**Initial Study/Mitigated Negative Declaration  
San José-Santa Clara Regional Wastewater Facility Outfall  
Bridge and Instrumentation Improvements Project  
File No. PP19-073**

**RESPONSES TO PUBLIC COMMENTS AND  
TEXT CHANGES**

October 2021

**Figure 2-2. Project Area Relative to Open Space in the Project Vicinity**

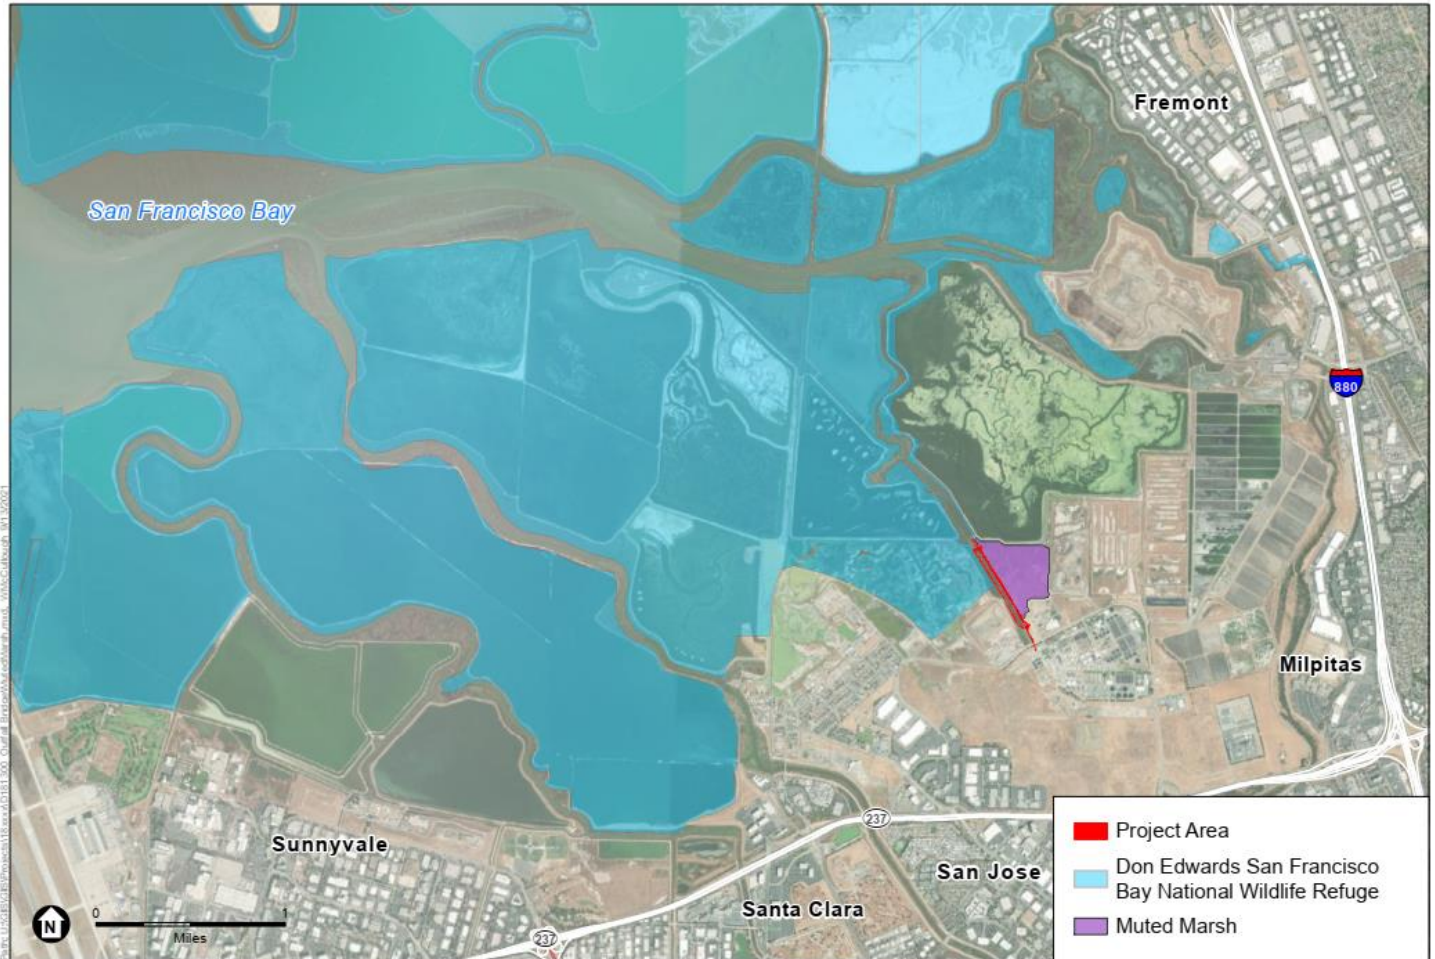
In addition, the Project is small in size relative to surrounding open space ~~and water~~, which would continue to provide movement corridors for ~~native~~ terrestrial wildlife, and project construction is expected to last a relatively short duration of 6 months. From a Project operations standpoint, and as described in Chapter 2, Project Description, ~~four~~ two LED

Page 2-46, new figure
